## ADDENDUM NUMBER 3

**1.01 DATE: MARCH 24, 2021**

**1.02 PROJECT: WELCOME CENTER**

**1.03 PROJECT NUMBER: DCM NO. 2020604**

**4.20 SHEET E-5.0 – AUXILIARY DETAILS 1:**

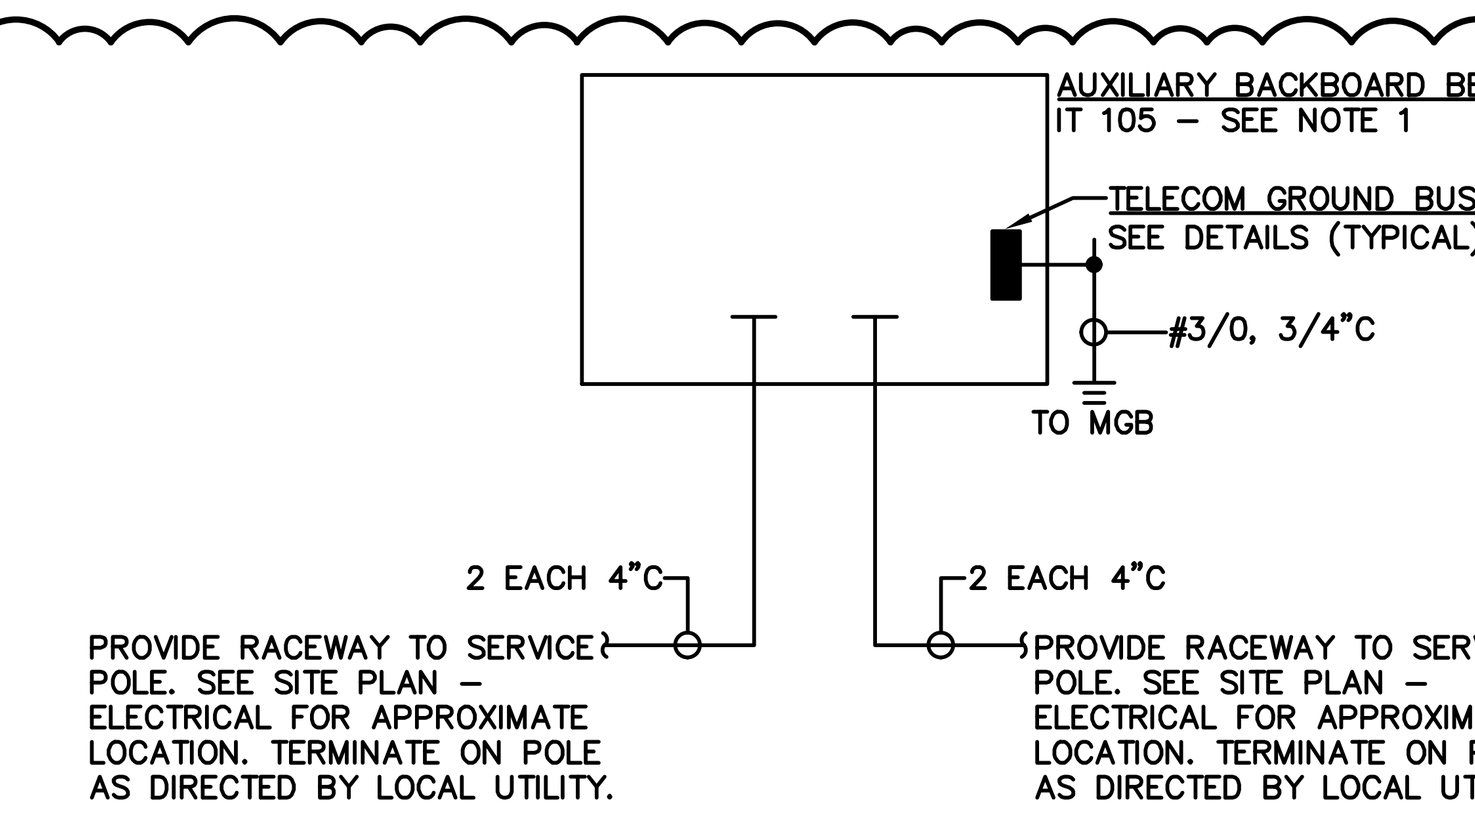
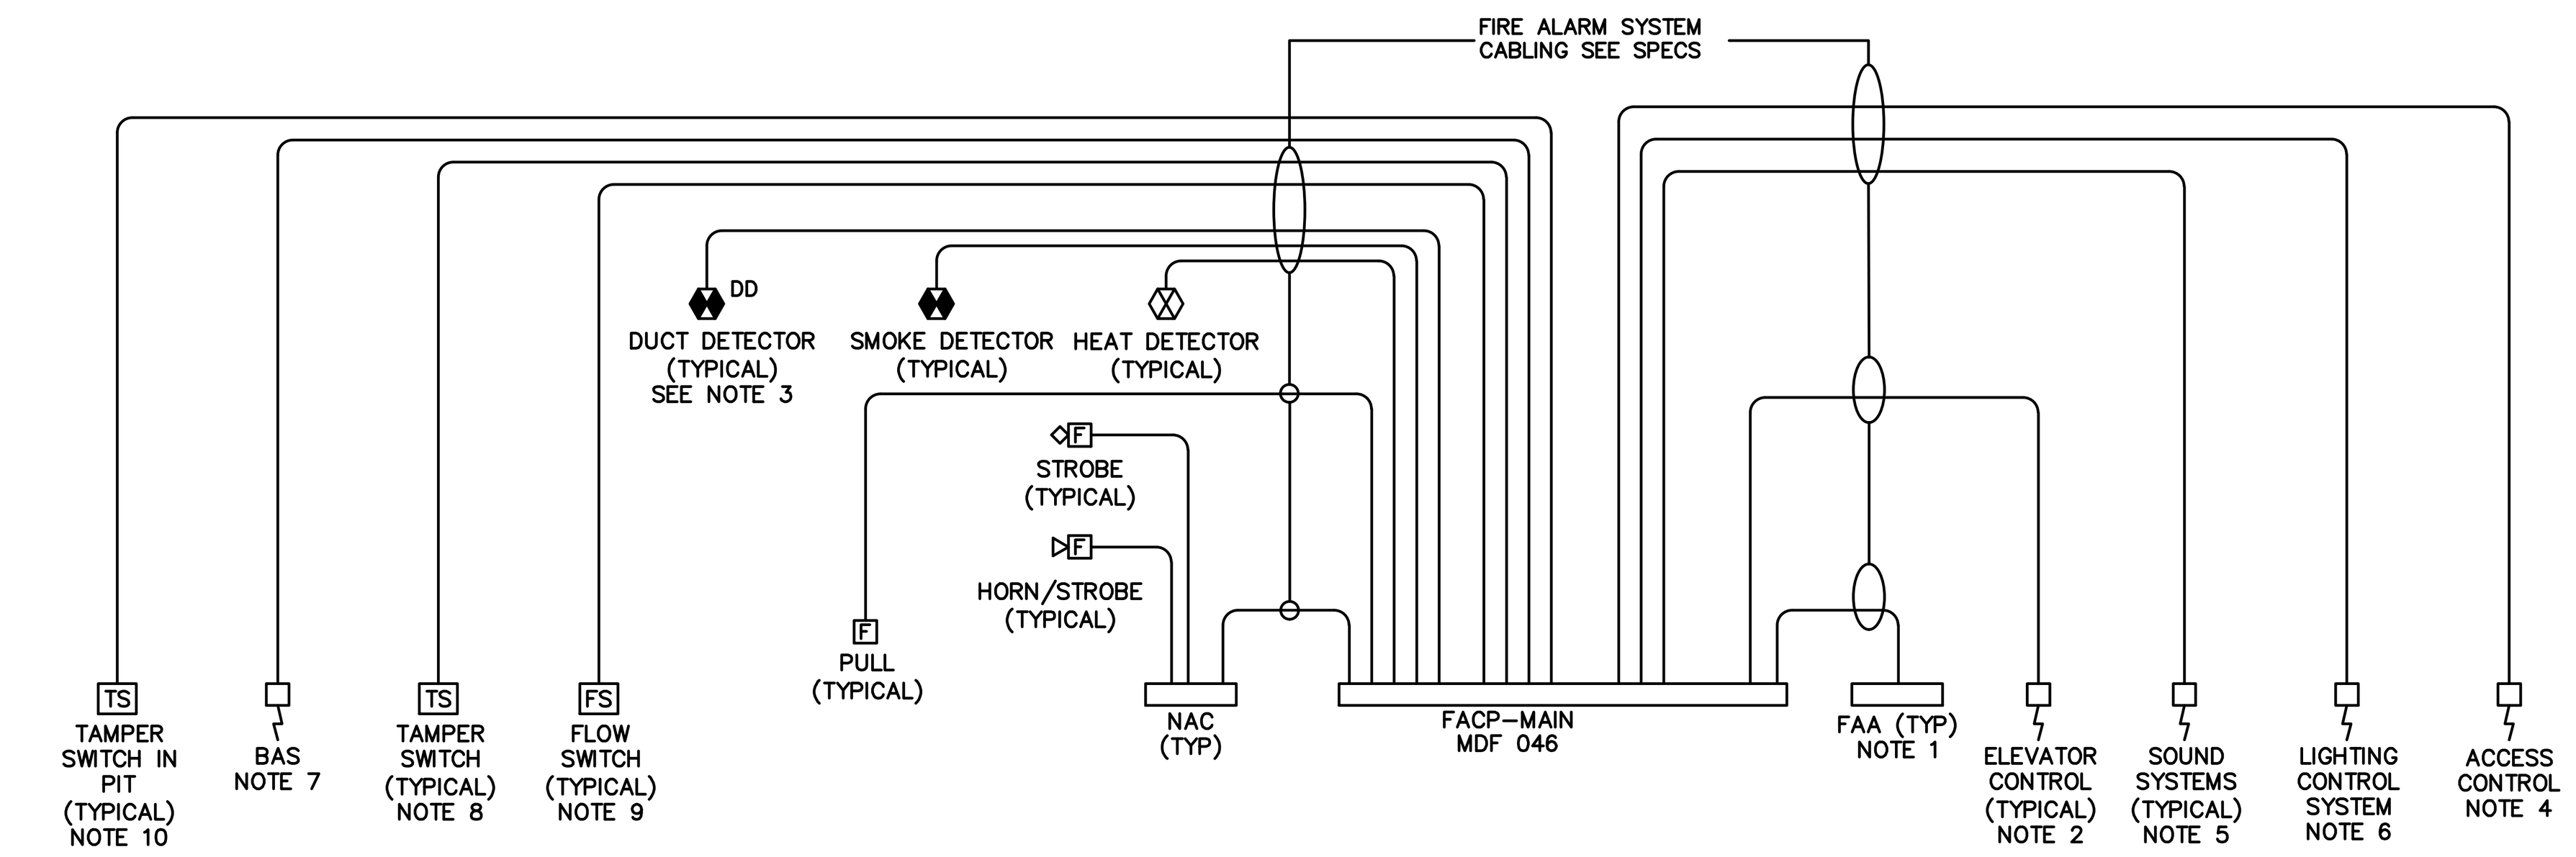
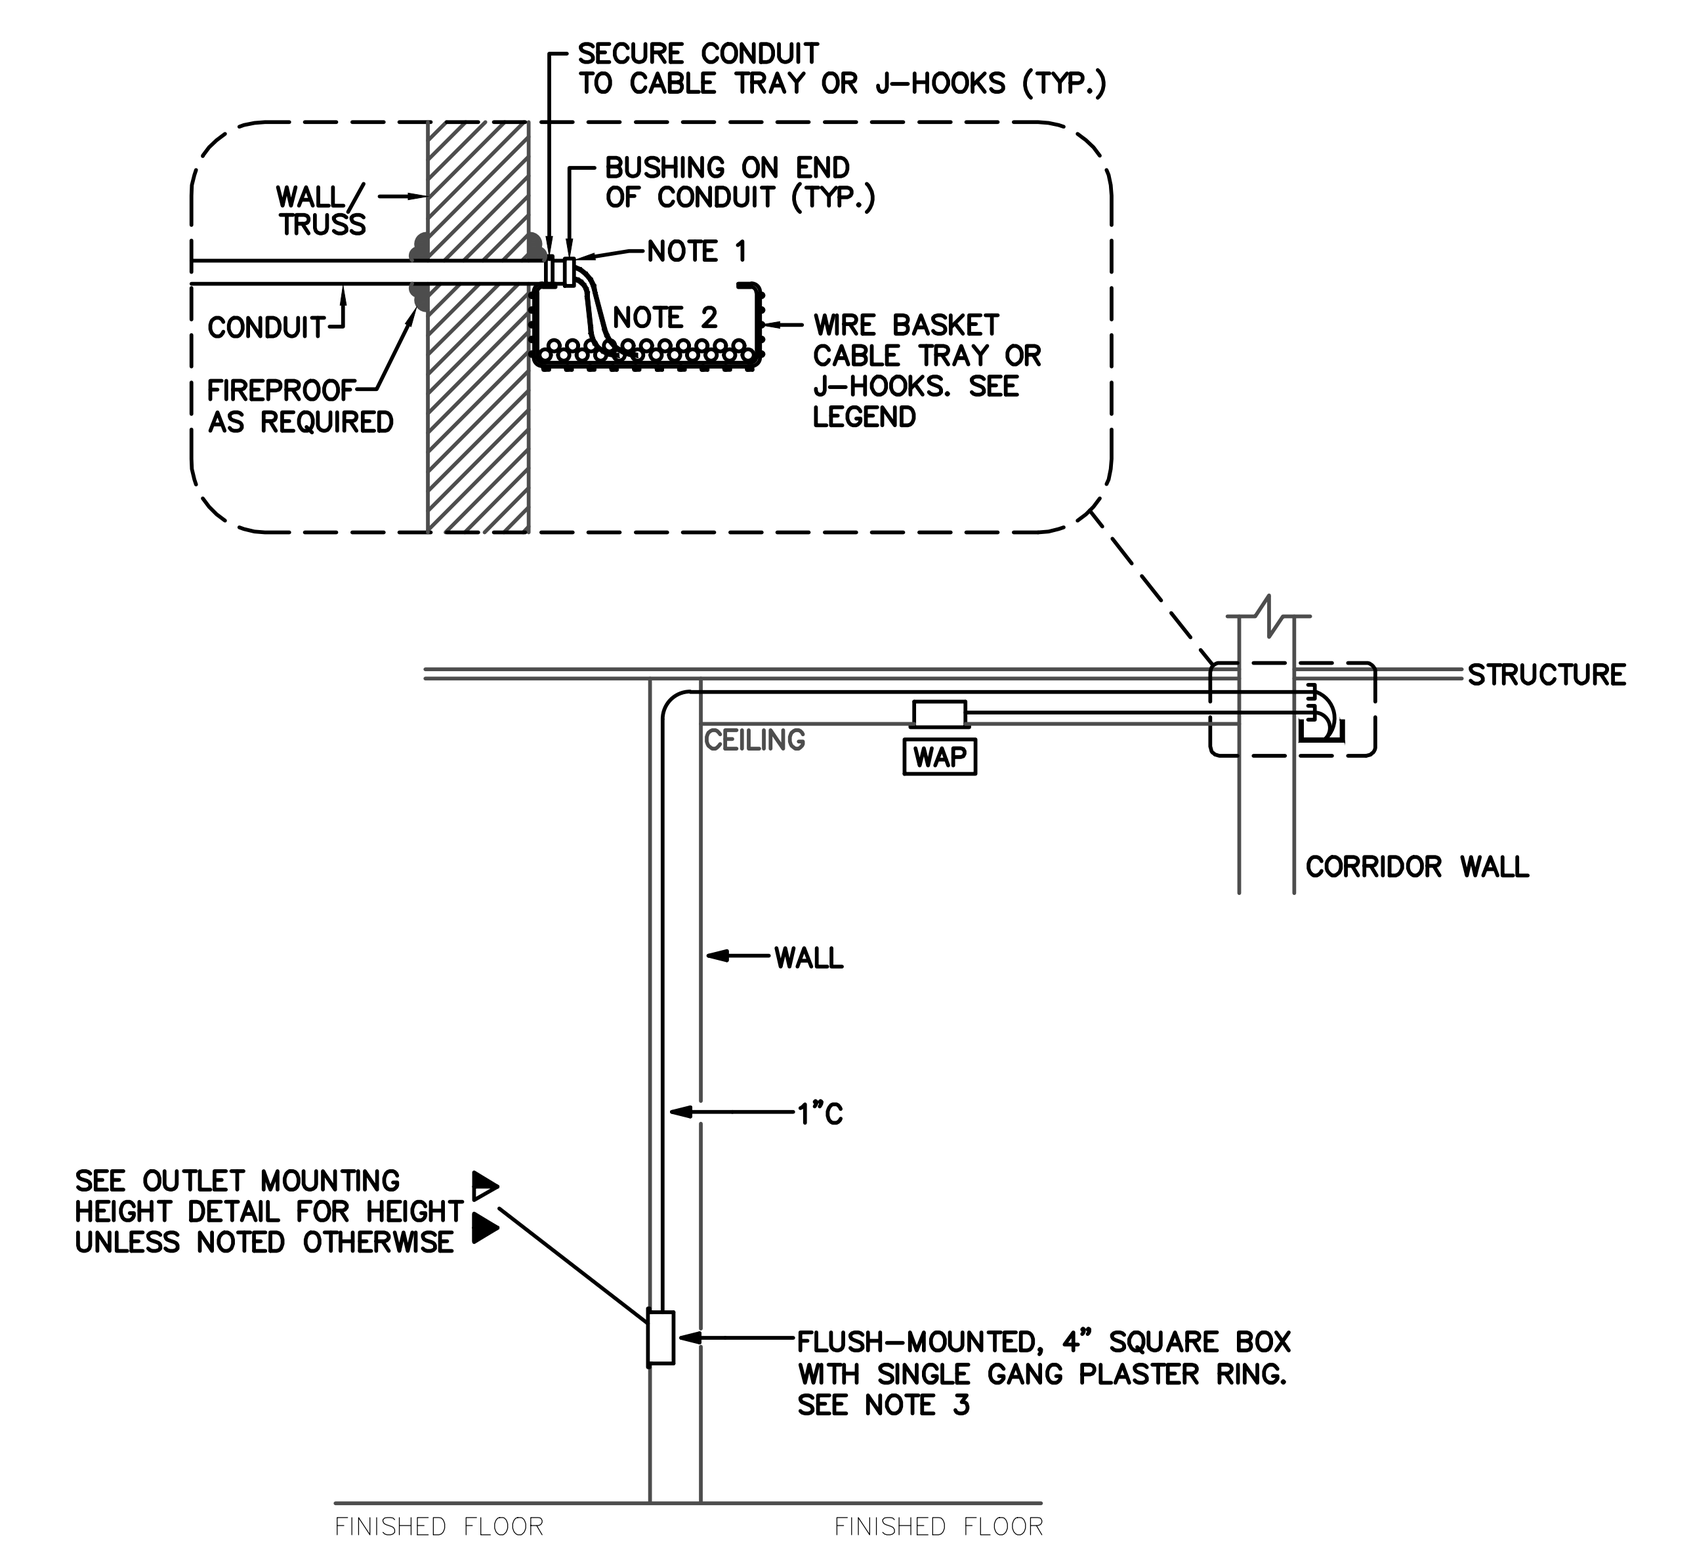
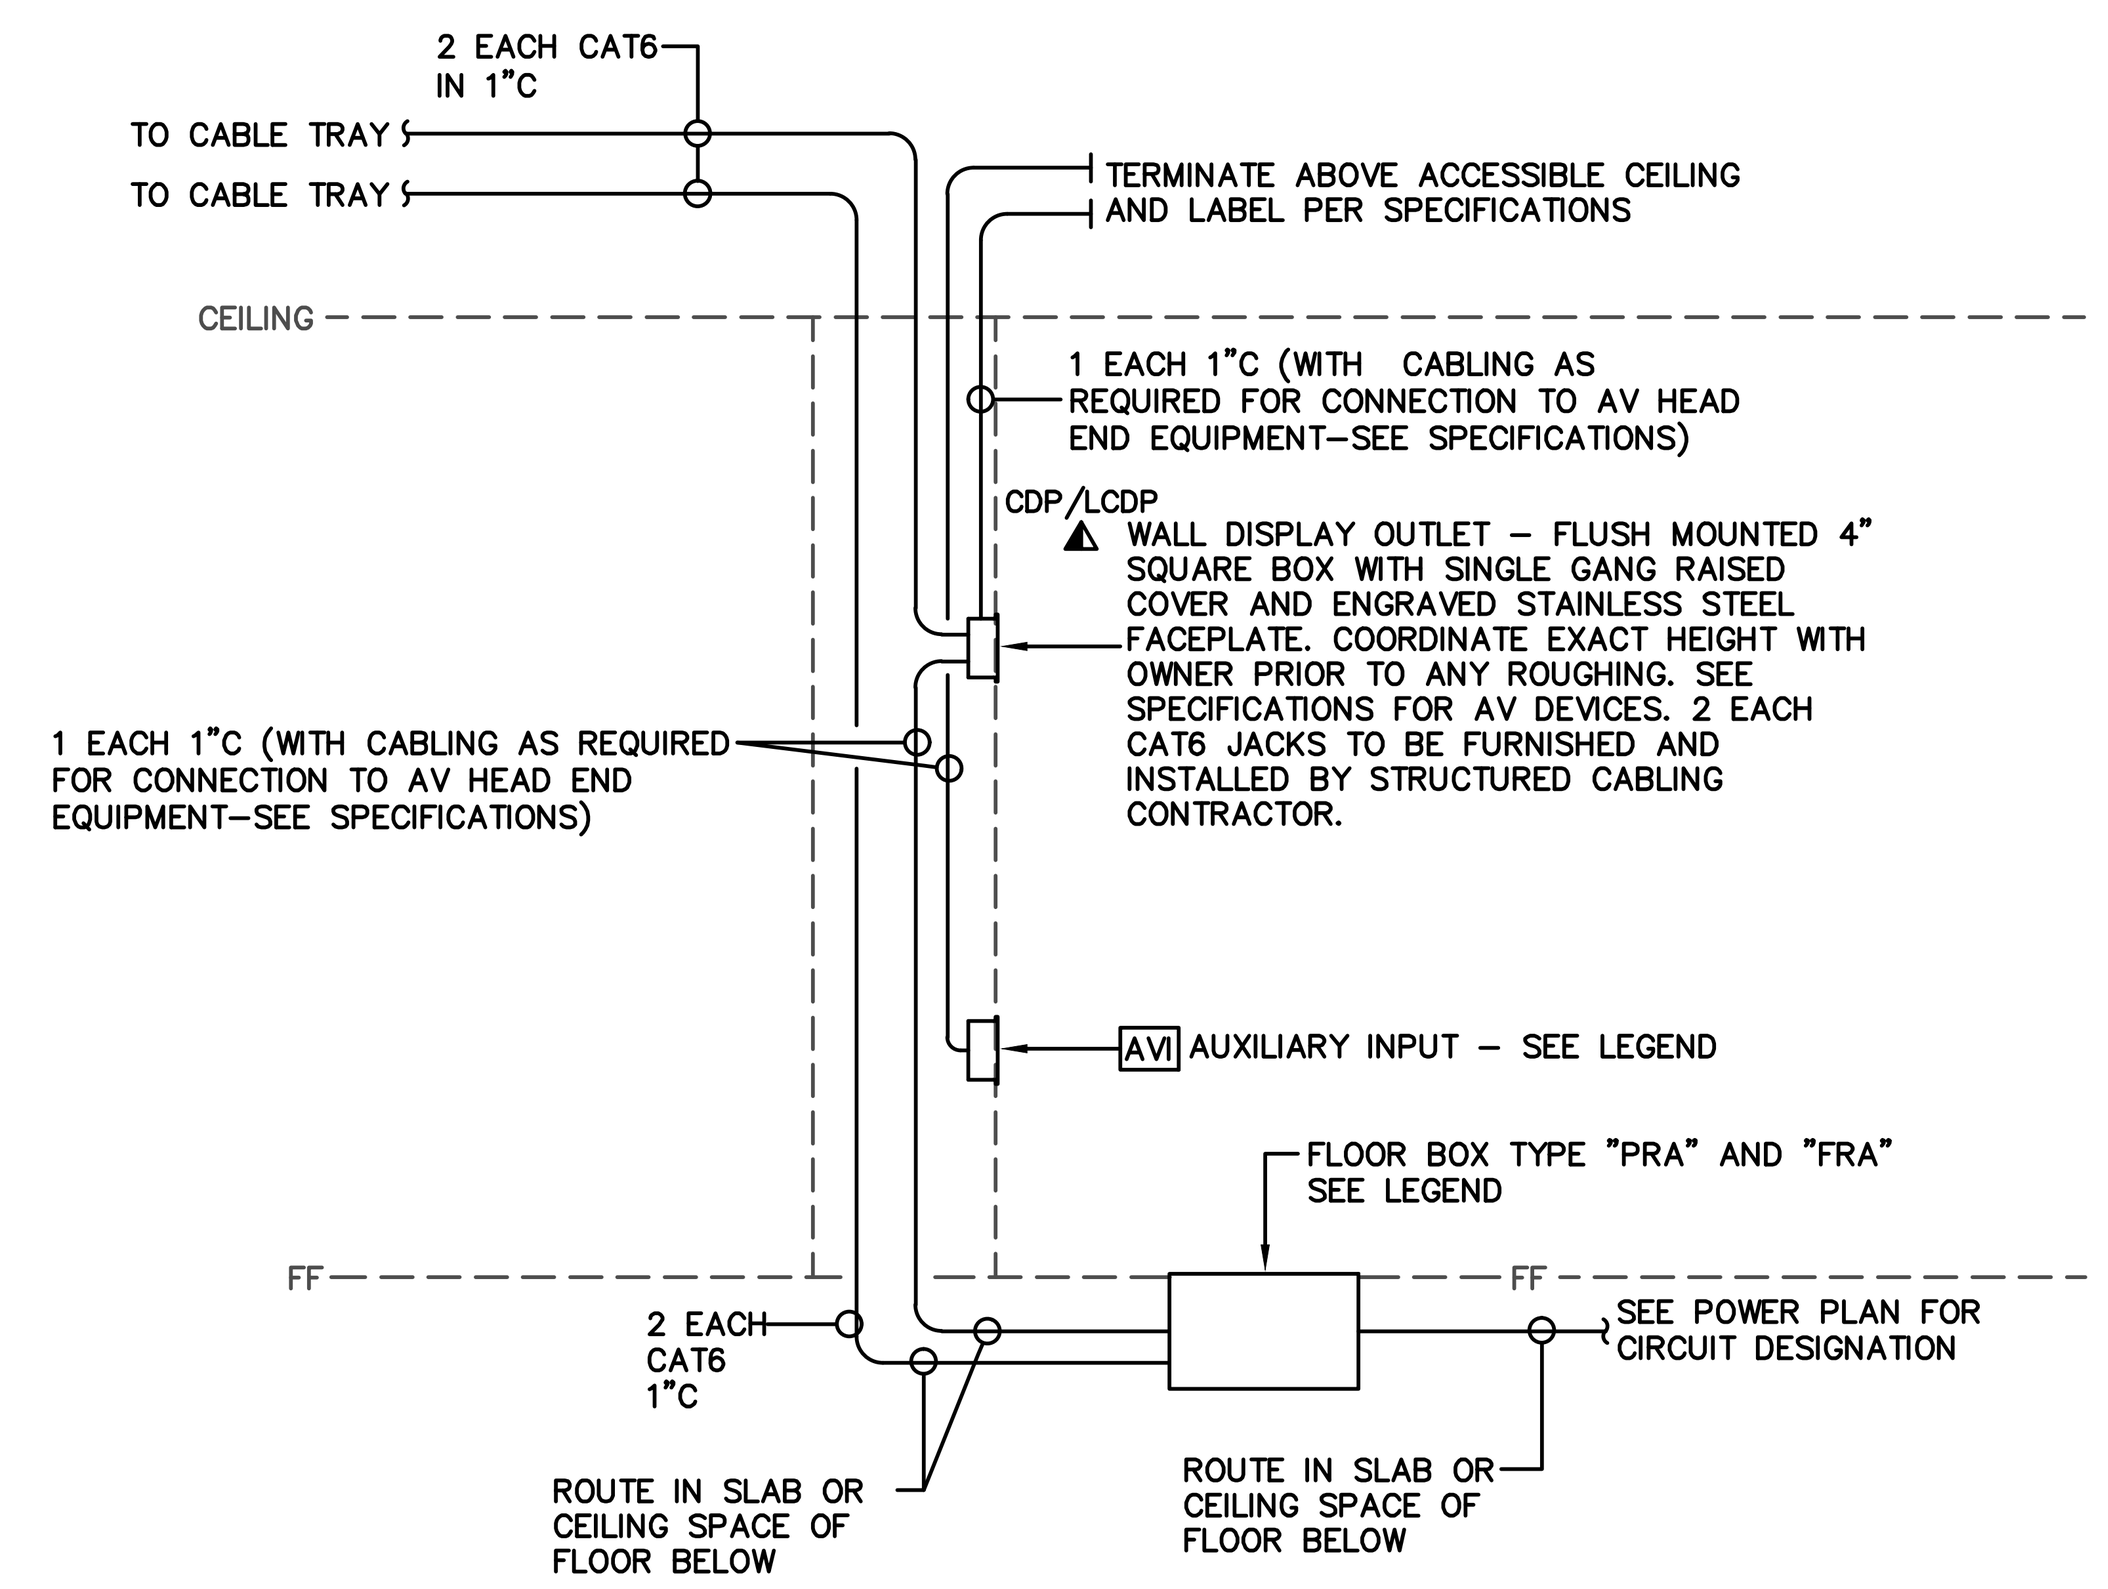
A. Replace this sheet in its entirety. Revisions include the following:
   1. Change reference at auxiliary backboard from IT XXX to IT 105.
   2. Change note number 2 to note number 1. Change notes number 3 and 4 to notes number 2 and 3, respectively.
